GE Hitachi Nuclear Energy

MFN 09-739

Subject: **Response to NRC Request for Additional Information Letter No. 383 Related to ESBWR Design Certification Application - Tier 1-RAI Number 14.3-449 S02**

RAI Number 14.3-449 S02

Figure 2.11.1-1. TMSS Functional Arrangement

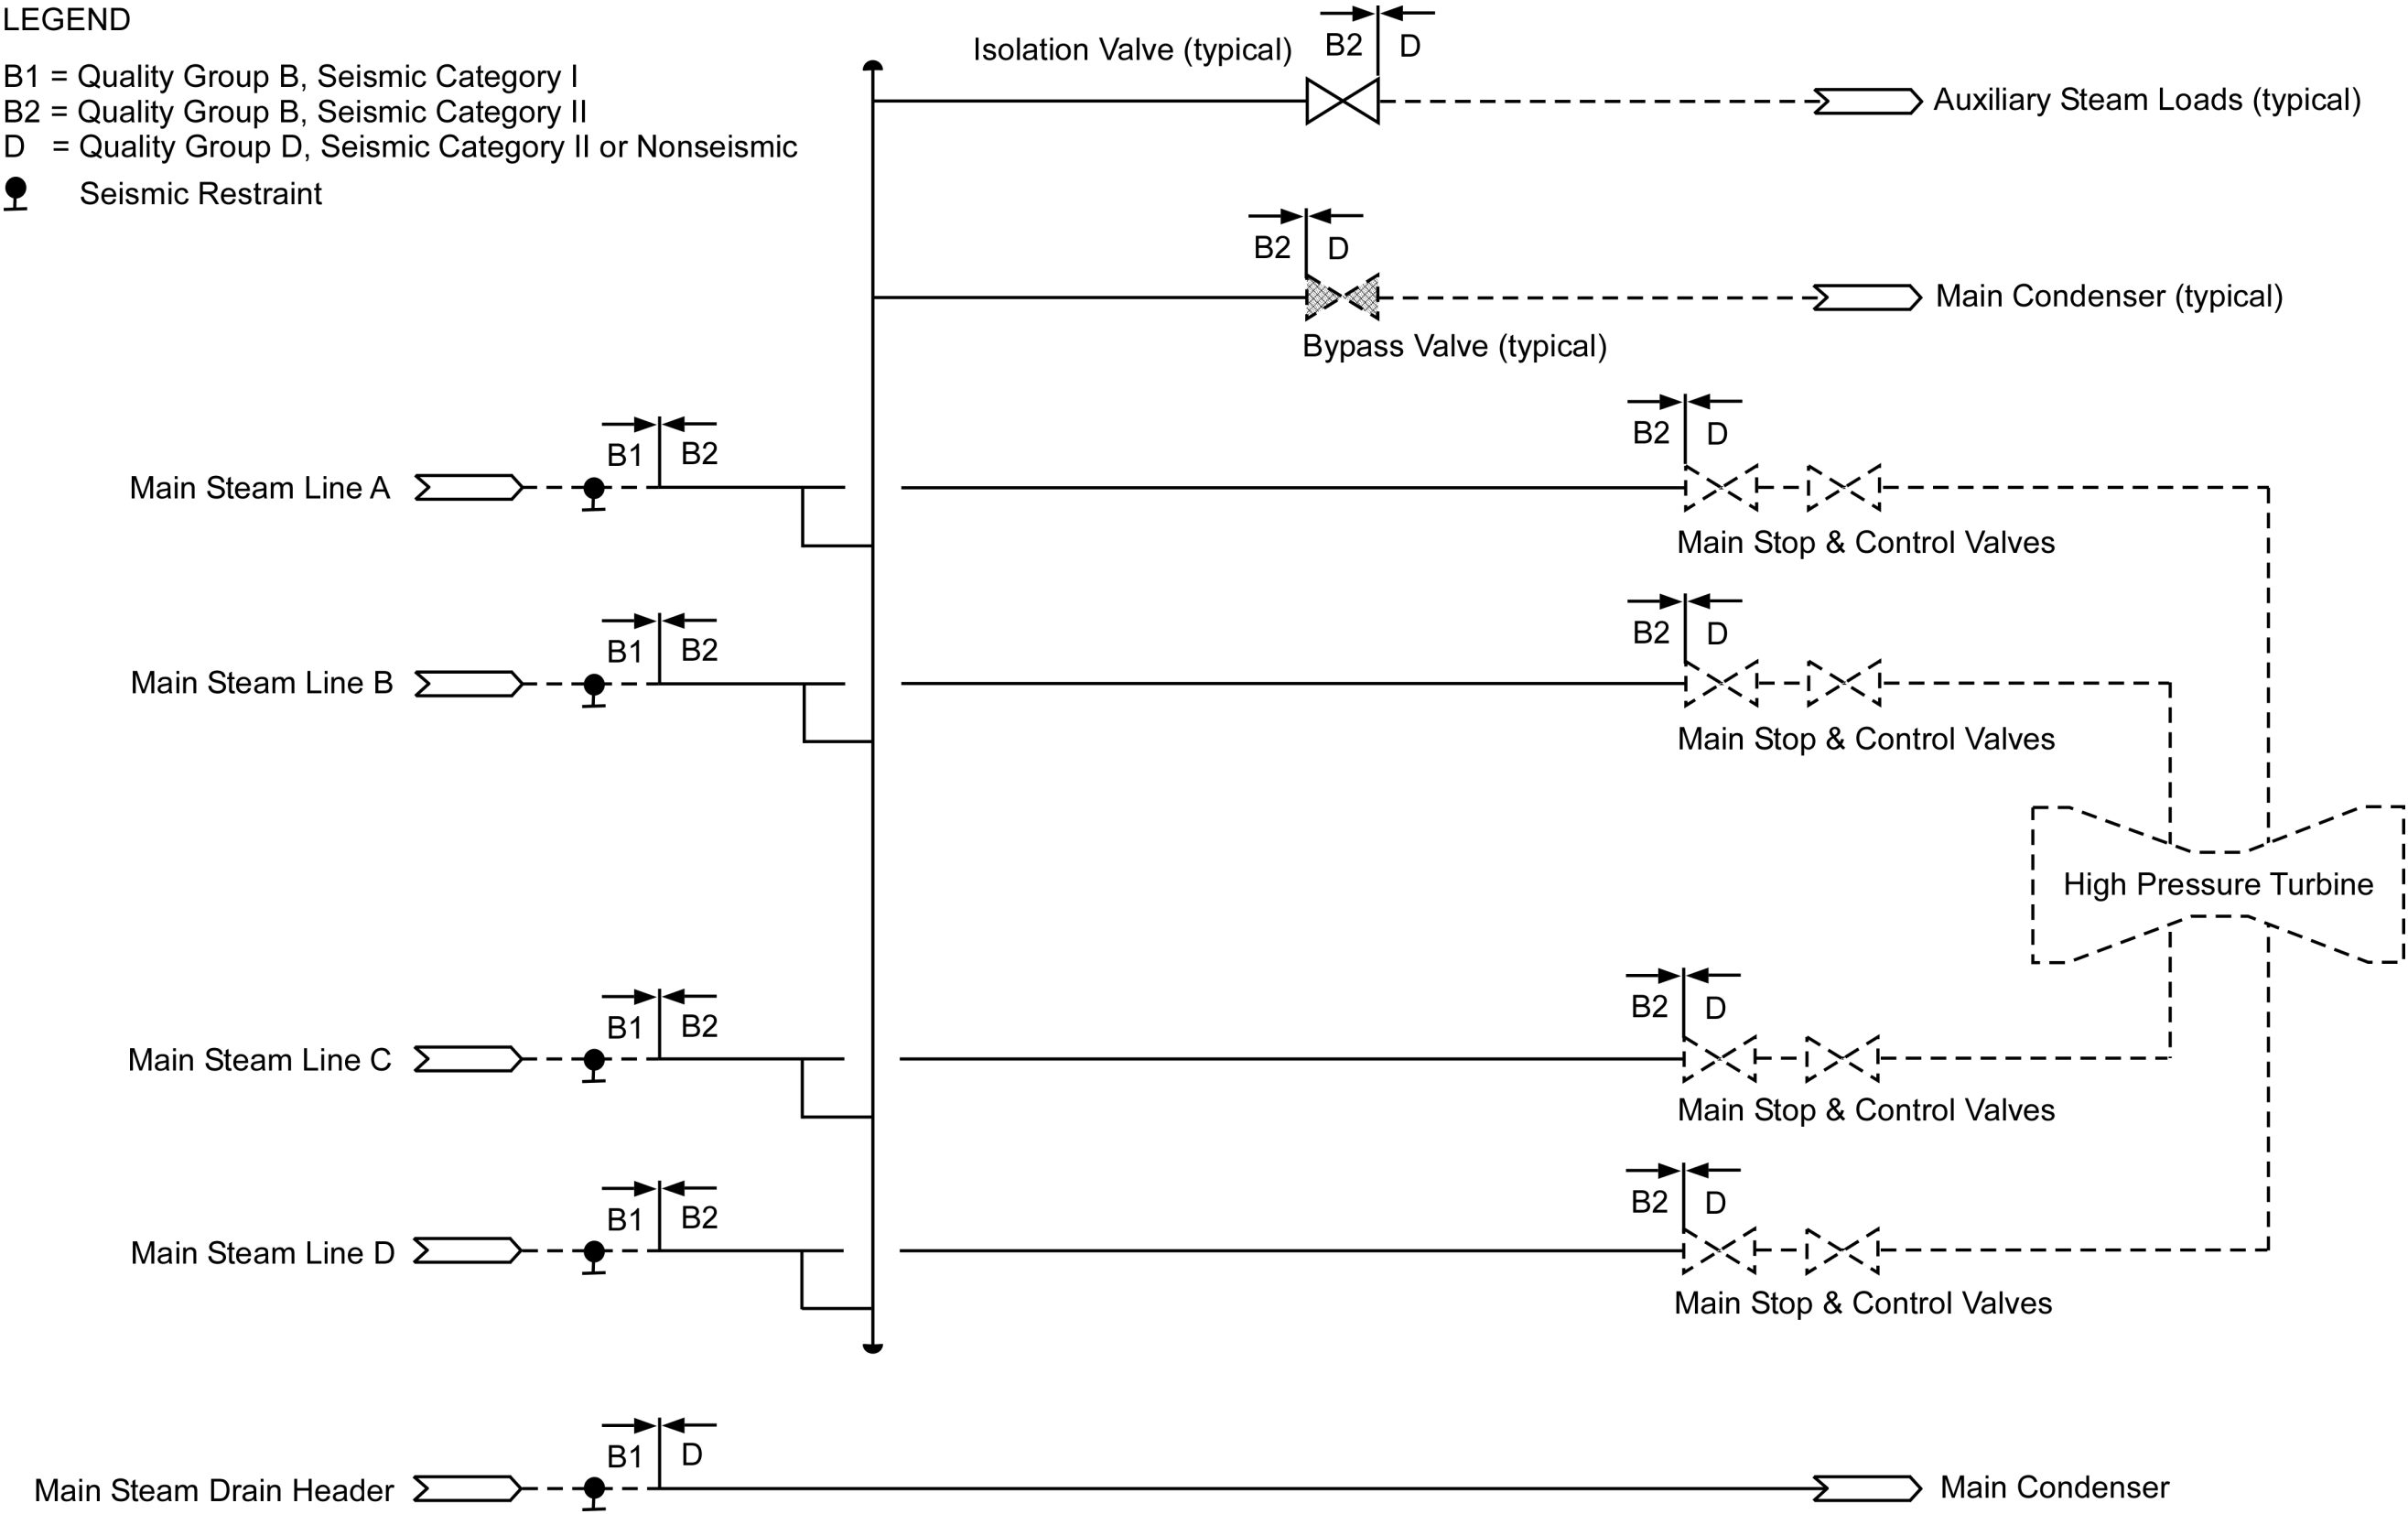
It is not suggested that the wording of ITAAC 2.11.1.5 be repeated in each and every ITAAC where the ASME scope is not clearly stated. However, it is recommended that since the ASME scope of the TMSS system has been pre-defined by RG 1.26, this level of detail (possibly by reference to some defining scope; e.g., a drawing or some other means) be communicated in the applicable TMSS ITAAC for both piping and components. This comment aligns with one of the general principles espoused for "inspectability" -- that the population of SSC that pertain to a specific ITAAC should be clearly specified (even if only by reference) in the ITAAC wording.

F.	S2.11.1, Design Description	<p>Based on 14.3-449 S02, Item #1 is modified to refer to new Figure 2.11.1-1 for the functional arrangement of the TMSS layout: “and as shown on Figure 2.11.1-1.”</p>

Item	Location in Tier 1	Description of Change
F.	T2.11.1-1, ITAAC #1	Based on 14.3-449 S02, ITAAC #1 is modified to refer to new Figure 2.11.1-1 for the functional arrangement of the TMSS layout: “and as shown on Figure 2.11.1-1.” This is added to both the DC and AC columns.

F.	F2.11.1-1	Based on RAI 14.3-449 S02, new Figure 2.11.1-1, TMSS Functional Arrangement, is added to show the layout of the TMSS and to identify the scope of equipment and piping within the TMSS for purposes of performing the ITAAC. The new figure is based on DCD Tier 2 Figures 3.2-1 and 10.3-1.
B.3 B.6	S2.13.1, Design Description	In Item 3a, “required by” is changed to “defined in” to reflect that a regulatory guide does not establish requirements. In Item 3b, “Separation is” is changed to “Physical separation and electrical isolation are” to reflect that the item covers both physical separation and electrical isolation, and “required by”
